DISTRICT OF COLUMBIA
A PLANNED UNIT DEVELOPMENT

MODIFICATION TO A CONSOLIDATED PLANNED UNIT
DEVELOPMENT APPROVED PURSUANT TO ZONING
COMMISSION CASE NO. 07-26

DRAWING INDEX

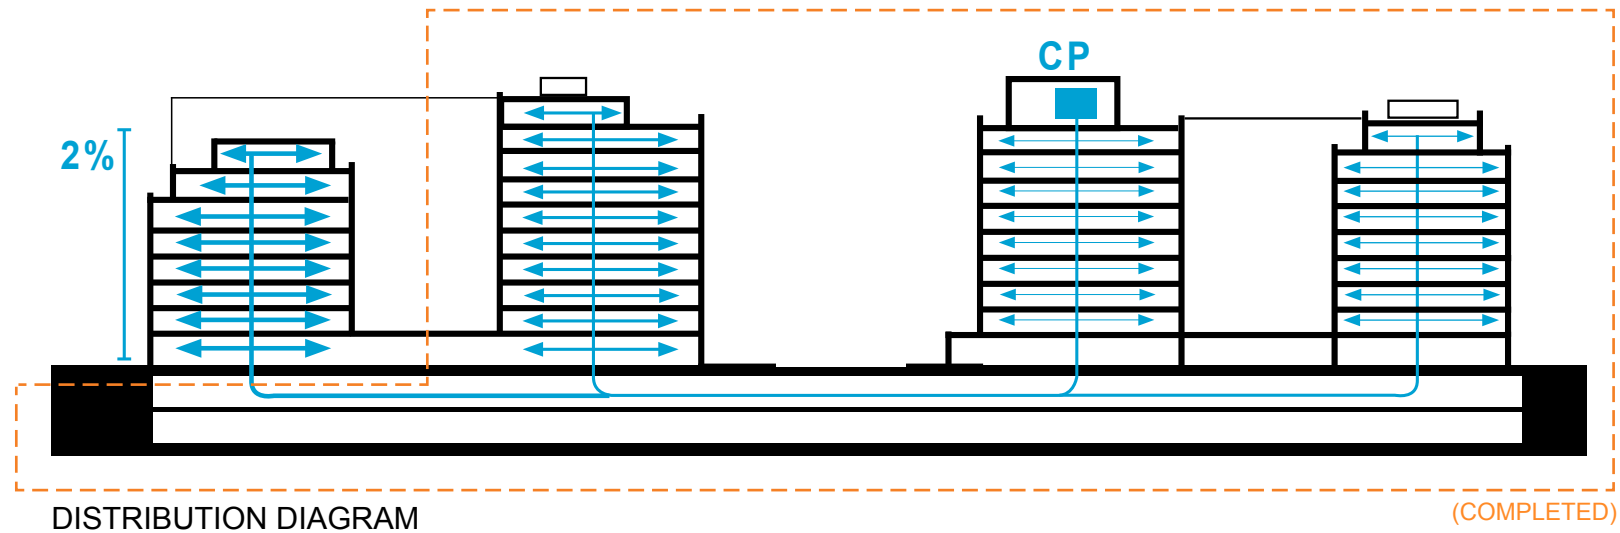
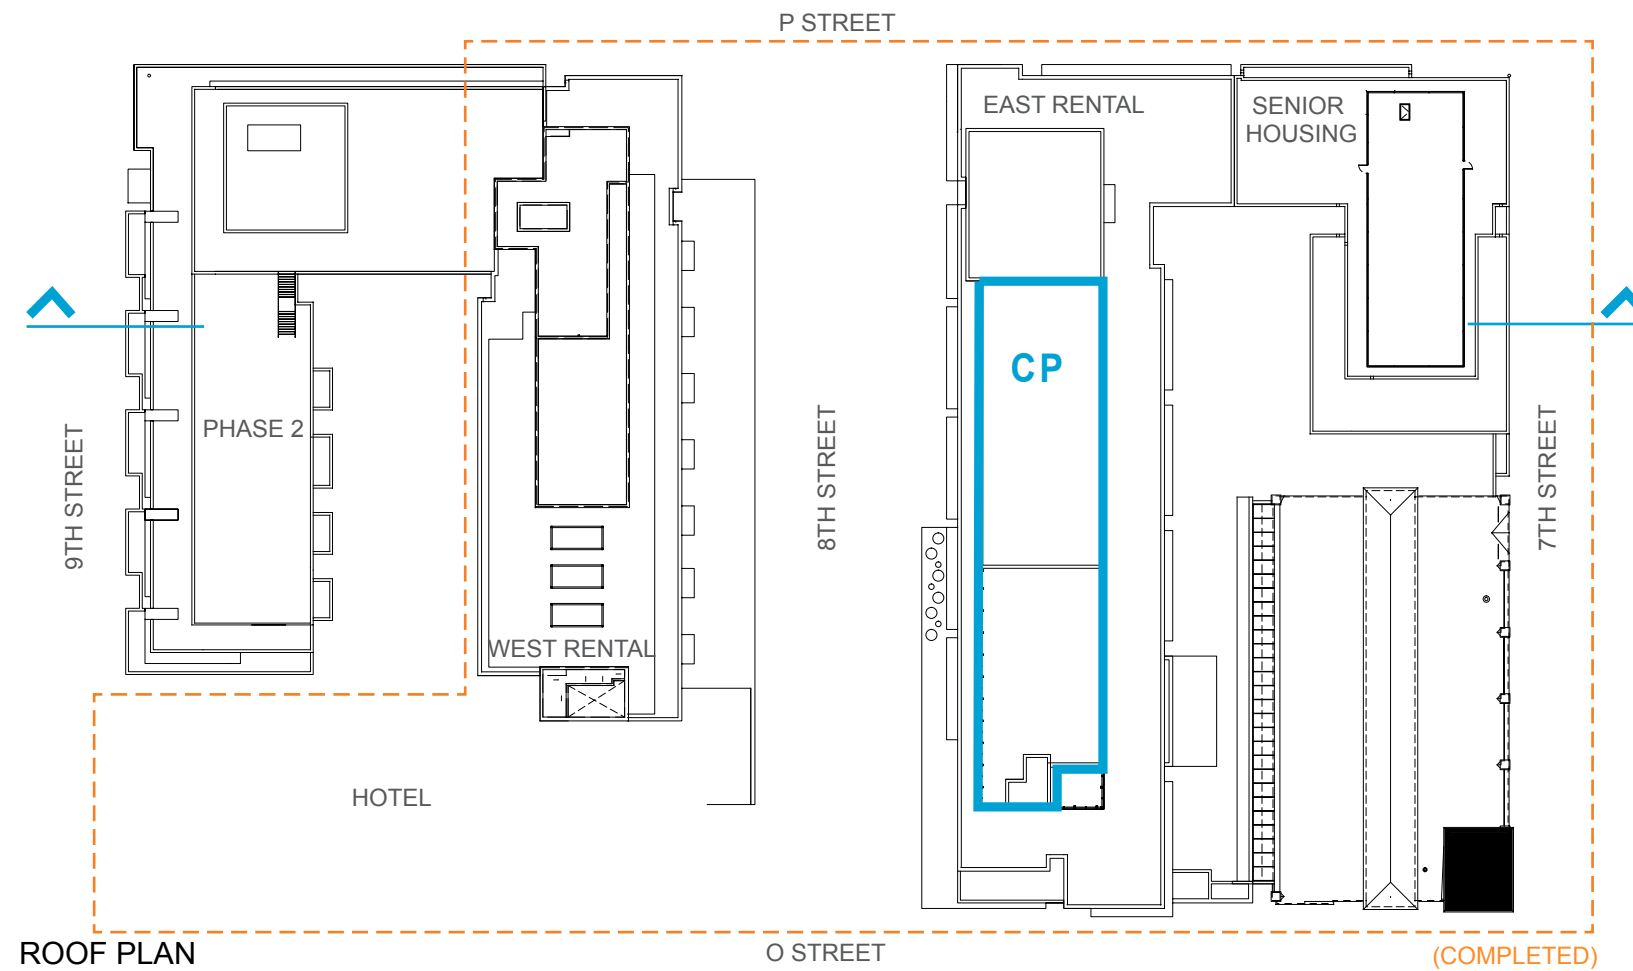
THE CONSOLIDATED CENTRAL PLANT (CP), BUILT IN THE PREVIOUS PHASE, ELIMINATES THE NEED FOR FUTURE MECHANICAL SYSTEMS ON REMAINING ROOFTOPS. HOWEVER, THE DISTANCE BETWEEN THE CENTRALIZED MECHANICAL SYSTEM AND THE FUTURE WEST BUILDING REQUIRES LARGER PIPING OVER TOP FLOOR CEILINGS TO PROPERLY SERVE THE NEW BUILDING SPACES. A 2% HEIGHT INCREASE WILL ACCOMMODATE THE SPACE NEEDED FOR THE LARGER PIPING.
